Product Change Notice (PCN)

PCN Number: **PCN-0456169R-01**

Product(s) Affected: *PJ-031CH*

PREVIOUS CUI DEVICES DETAIL / IMAGE	NEW CUI DEVICES DETAIL / IMAGE

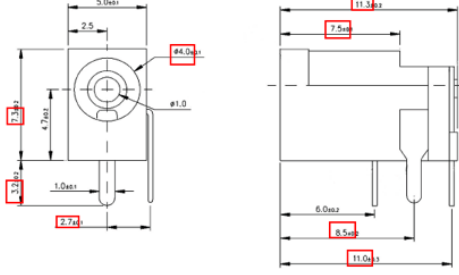
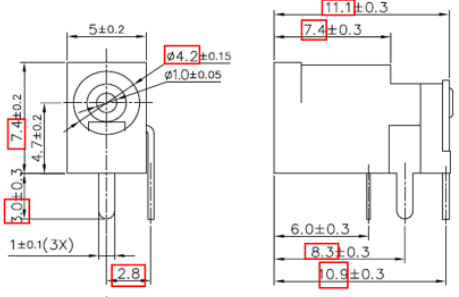
Description of Change: *Product re-engineered for improved manufacturability and production yield. See image below for product changes. Cosmetic differences may be visible and not affect the form fit and function of the product.*

<p>Recommended PCB Layout Top View</p>	 <p>Recommended PCB Layout Top View</p>

PREVIOUS CUI DEVICES DETAIL / IMAGE			NEW CUI DEVICES DETAIL / IMAGE		
DESCRIPTION	MATERIAL	PLATING/COLOR	DESCRIPTION	MATERIAL	PLATING/COLOR
center pin	brass	silver	center pin	brass	CuSn
terminal 1	brass t=0.50	silver	terminal 1	brass t=0.40	silver
terminal 2	MM alloy t=0.20	silver	terminal 2	stainless steel t=0.20	silver
terminal 3	brass t=0.50	silver	terminal 3	brass t=0.40	silver
housing	PA10T (UL94V-0)	black	housing	PA10T (UL94V-0)	black

<p>MATING PLUG Jack Insertion Depth: 7.0 mm</p>	 <p>MATING PLUG Jack Insertion Depth: 6.2 mm</p>
--	---
